Subject: Resolution #17-16, B & B Mower Property (Railroad Ave.), Swing Line Grill, City Parking Lot

Request for a Swing Line Grill Initial Development Plan and request for a Parking and Sign Height Variance

ARO MEMO

Swing Line Grill
Railroad Avenue
Madeira, Ohio 45243

Preliminary Development Plan
 SCALE: 1" = 20'-0" (11" x 17")
 May 26, 2016

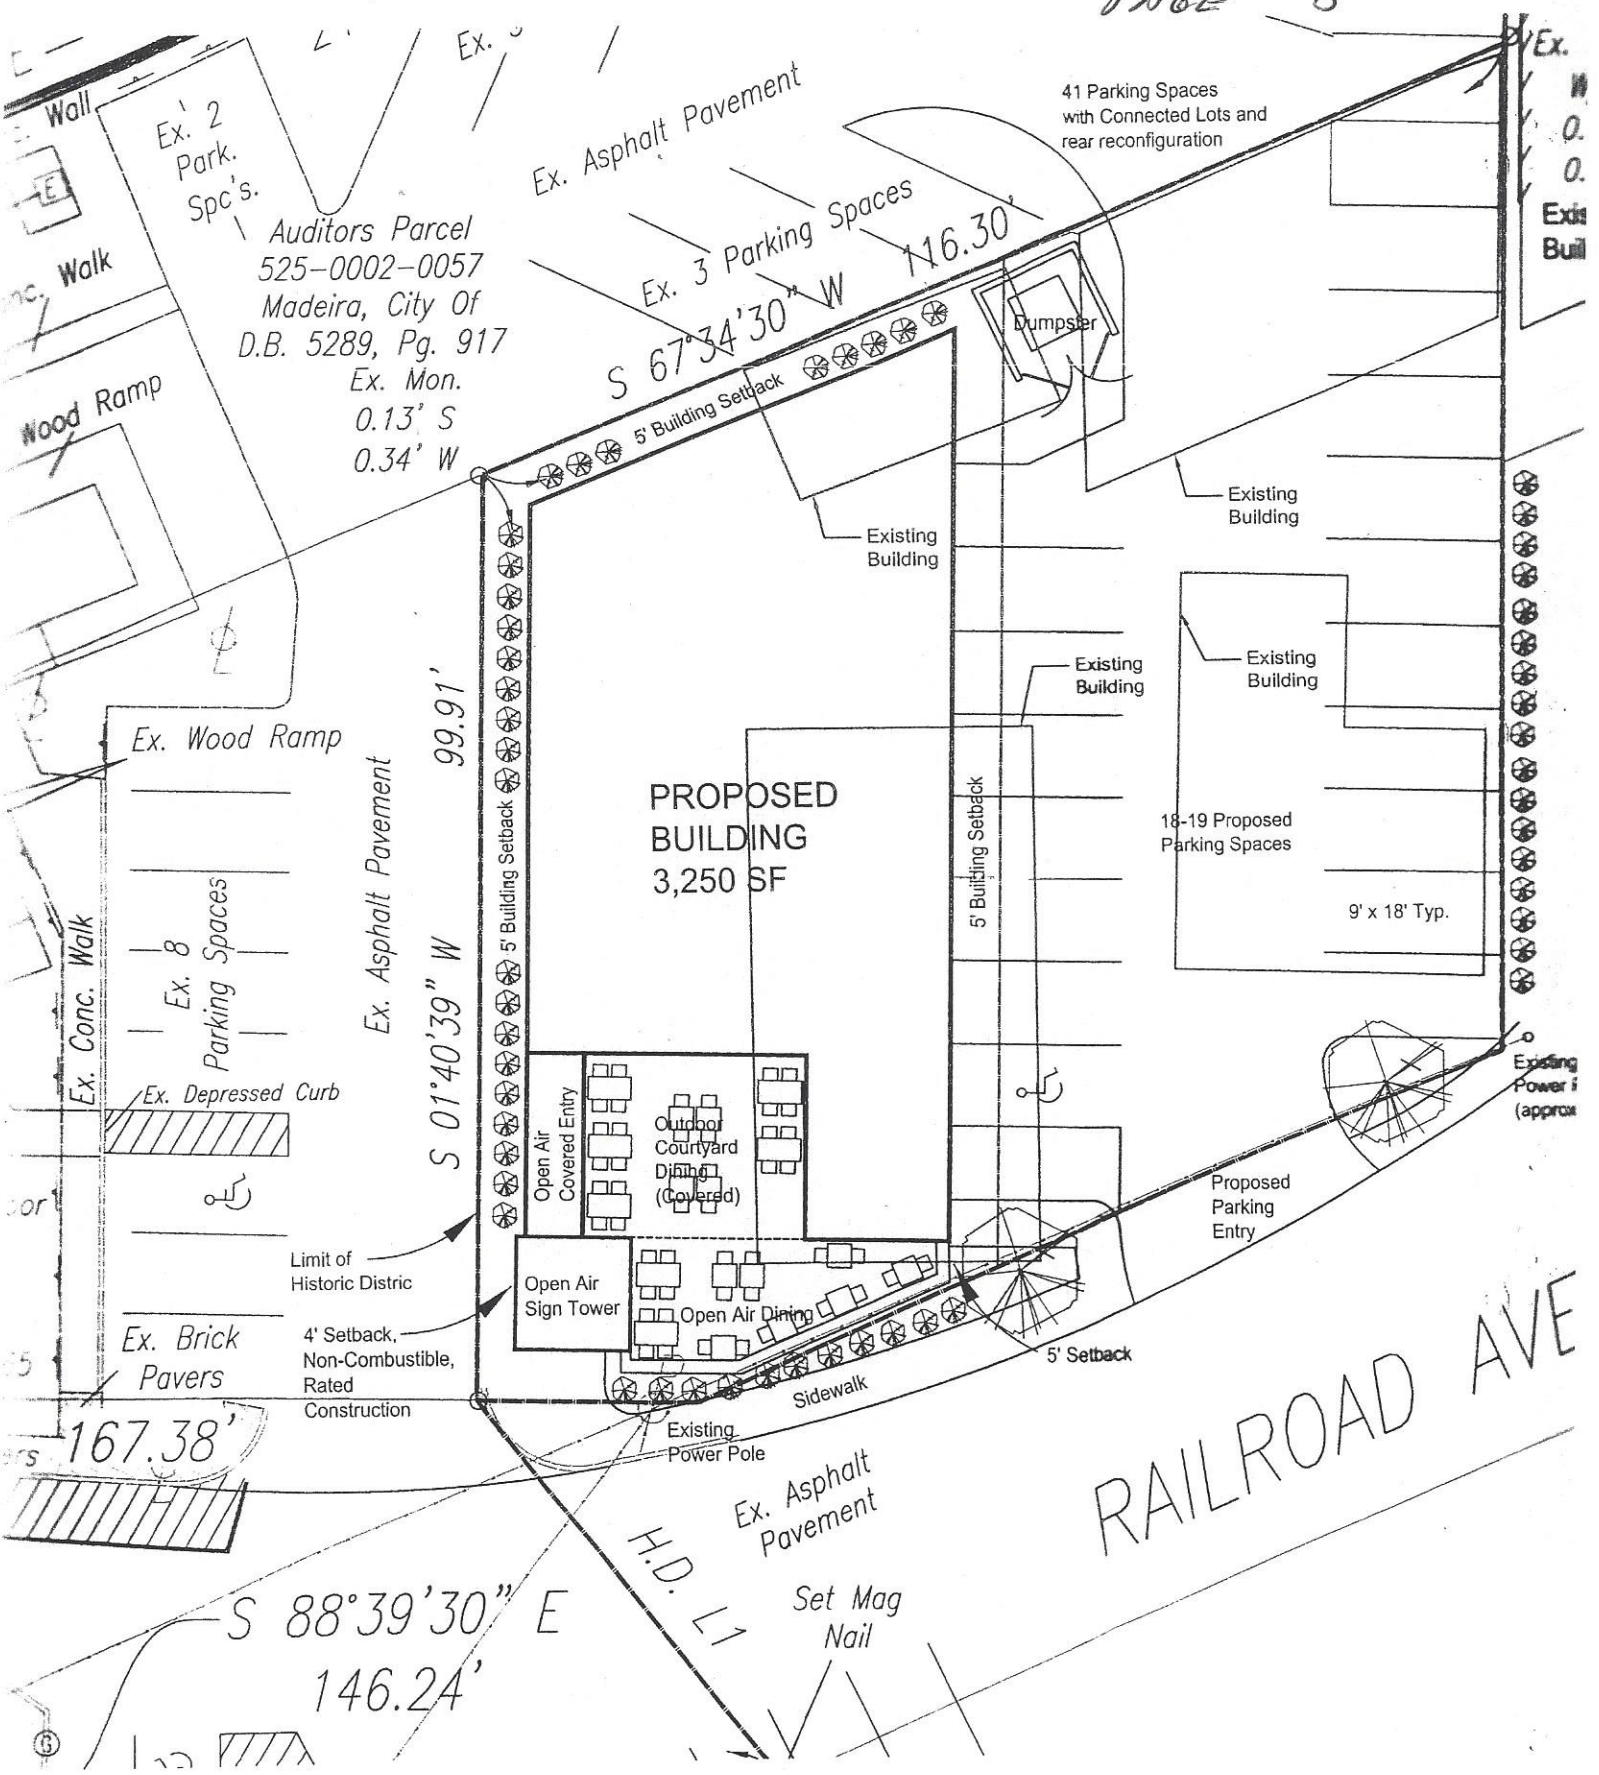
a) This Staff Report comment has absolutely no relevance to the issue at hand. The drawing shows a 15 foot long building wall at the south-east front building corner. Its set-back ranges from 5 feet back from the south-east build-to lot line, to, 12 feet back at the west end of the 15 foot long building wall. The drawing shows a 19 foot deep set-back wall to the north, and then, a 29 foot long wall to the west which becomes the south-west building corner. Section #166.57 (2) says the city may allow up to 50% of this 44 foot wide building to be set-back for façade articulation etc. This drawing shows the building contains a 29 foot building front façade set-back which exceeds the 50% limitation - or 22 foot limitation. The Staff Report makes no mention of this issue and makes no request for relief by variance from these requirements.

b) This Staff Report makes no mention about the 2 foot high “wrought iron fence above the low 1-1/2 foot high brick wall” shown on the May 23, 2016 drawing of the building front elevation facing Railroad Ave. This 25 foot long 3-1/2 foot high brick wall and fence will be set-back less than one foot from the property line. As the zoning code (Section #166.56 (A), Exhibit #4) requires a 5 foot set-back from the front yard lot-line, another zoning variance request and approval is required on this issue but not mentioned in the Staff Report.

c) The Staff Report states: “The applicant is also proposing plantings along the front of the outdoor dining area.” The Staff Report fails to mention that 8 of the 11 plantings are shown being planted within the Railroad Ave Right-of-way. Surely this is an encroachment of a

- e) Another set-back issue deals with the rear yard "minimum 5 foot set-back from the rear lot line" in the area where a portion of the "private dumpster enclosure" will be located less than 2 feet from the rear property lines of both properties. Again, this issue is not mentioned in the Staff Report. A variance is required here again. Just as with the previous issue, I don't believe the Planning Commission has the authority to waive these set-back requirements when a new structure is being built.

- 1) The Staff Report states: "The applicant has provided a site plan with the set-backs shown. It is at a scale of 1 inch equals 20 feet. Drive ingress and egress are shown. Public parking is shown on the plan but no designated parking." This means the Swing Line Grill / Mr. Thomas Powers has no power to dictate or control any portion of the public parking lot for any purpose; parking, delivery, dumpster service, no control whatsoever. Although the parking lot is contiguous to Mr. Powers property, Mr. Powers cannot claim ownership or control of even one legitimate parking space so to begin to comply with Sections #150.24 and #150.16 of the zoning code.

Preliminary Side Elevation (East)
SCALE: 1/8" = 1'-0"

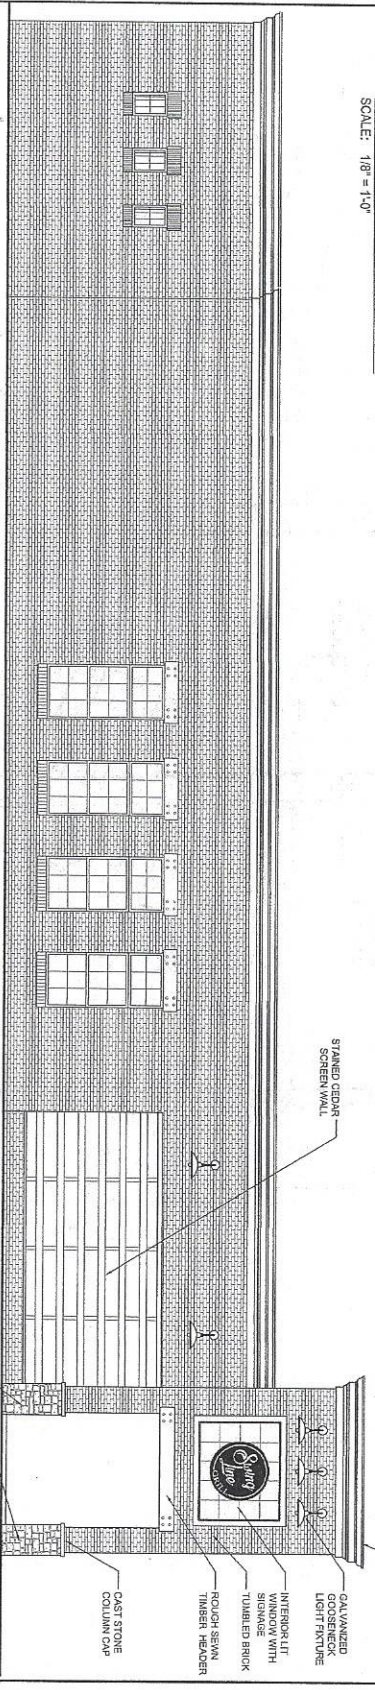
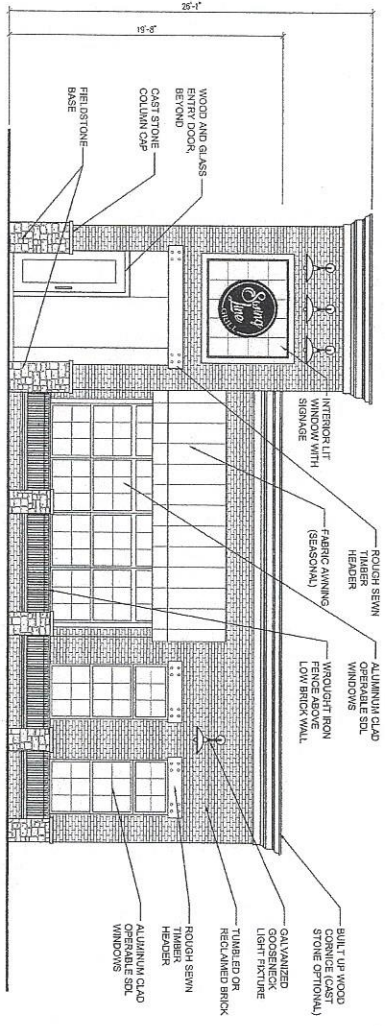
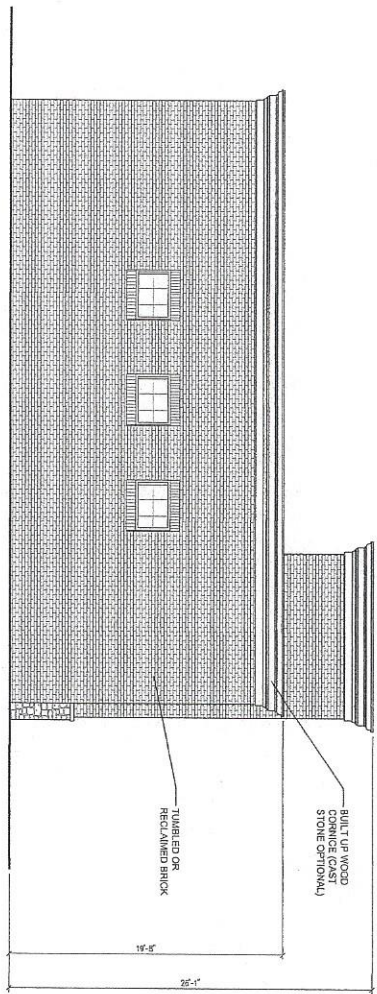
- 1) It would be helpful for the applicant to submit for review a floor plan of the proposed building.
- 2) The stone base and water table be continued around the base of the building on both the East and West elevations.

- 3) Submit pictures and/or cut sheets of the type and coursing of the stone material to be selected.
- 4) Replace the rough sawn timber lintels over the windows and doors with a precast or cut stone to provide a finished appearance and match the color and material of the cornice.

- 5) Continue the parapet detail on the East elevations and install leader boxes with downspouts.
- 6) Provide an additional roof top screen around the equipment if required.
